***REMARKS***

**Response To Drawing Objections**

*Annotated Drawing sheet*

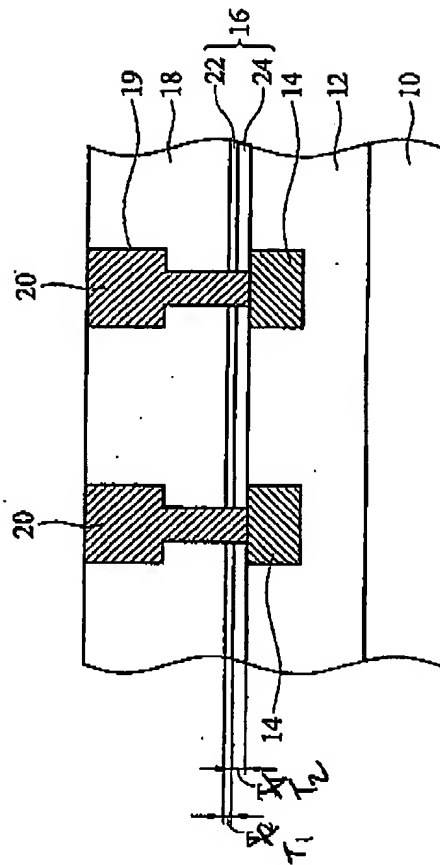
The drawings were objected to for certain inconsistencies between the specification and the drawings. Replacement sheets are included in this response to correct the inconsistency between the specification and the drawings. Especially, labels T<sub>1</sub> and T<sub>2</sub> in Fig. 2 are interchanged as the Examiner has recommended, and "5.6x10<sup>9</sup>" of Example III in Attachment is changed into "5.6x10<sup>8</sup>."

The Applicant believes that the drawings reflected in the replacement sheets overcome the objection.
